No: 97117-231
Subject: HN AUXILIARY SHIM SPECIFICATION
Date: JUNE 2011 Revision: A

All production suspensions from Hendrickson Asia Pacific Pty Ltd are equipped standard with three shims, as pictured at figure 1

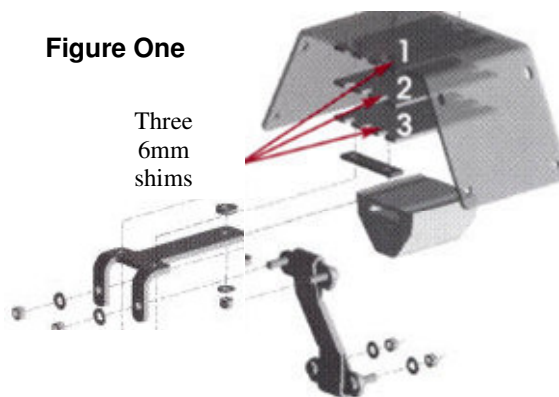
Effective from November 2000 an improved auxiliary spring assembly and shim design was introduced into the market for HN402 series suspensions. This new design:

- Addressed the importance of matching ride quality and stability.
- Enabled adjustability to achieve the correct ride performance and handling based on specific applications.

A small percentage of vehicles may require a shim system outside of the standard production build. To assist customers to determine the correct amount of shims to meet their unique vehicle configuration refer to Table 1.

Install or remove shims in order to reach the recommended number of total shims per saddle.

Important: Each side of the HN suspension must have an equal number of shims in place
Shim Part Number: 58960-001
